67478 County Permit Review Worksheet

IMPROVEMENT PERMIT for a RESIDENTIAL ON-SITE WASTEWATER TREATMENT & DISPOSAL SYSTEM

GWS Septic System Design Review

RE: Request for an Improvement Permit for Lot 9 off of Sample Road.
MCHD File #6747B

Scale: 1 inch equals 50 feet	S&ME	Faison-Sample Road, LLC	FIGURE
Drawn by: JBP		Lot 9	1
Reviewed by: Jeremy P. Michelone, RS		Mecklenburg County, NC	
Date: February, 2007	ENVIRONMENTAL SERVICES · ENGINEERING · TESTING	S&ME Project #1588-05-091

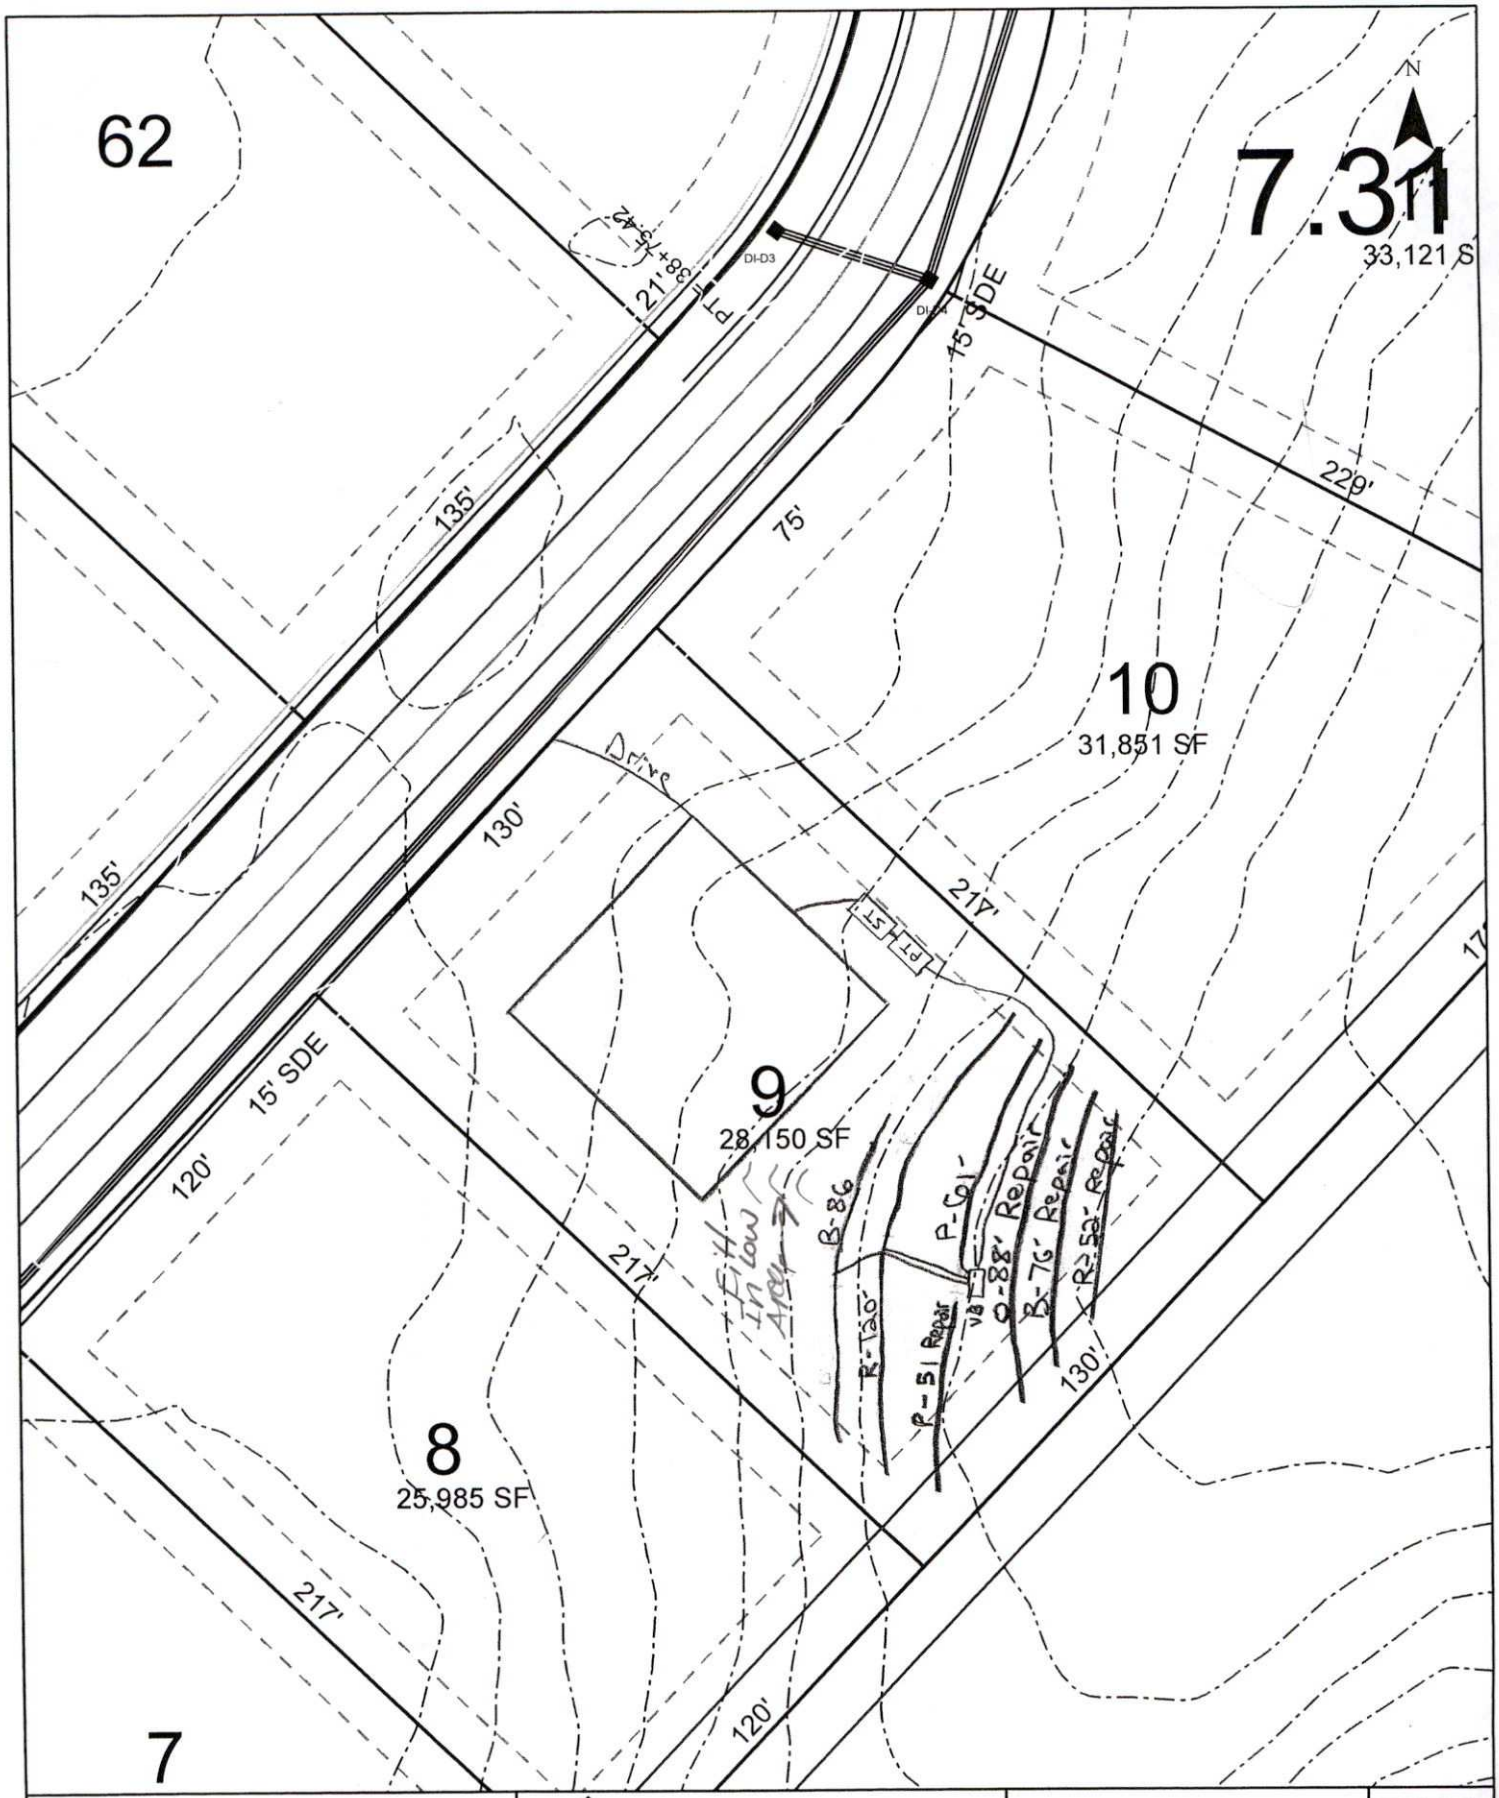
Please review the attached system sketch and design specifications for the Improvement Permit. Any additions or revisions you feel are necessary can be made on the Improvement Permit. Please call if you have questions or comments.

√TCT 3-21-07

Approved	Disapproved
GWS File #: 6747 B		
Design Review: TCT 3-21-07	☒	☐
Field Review:	☒	☐
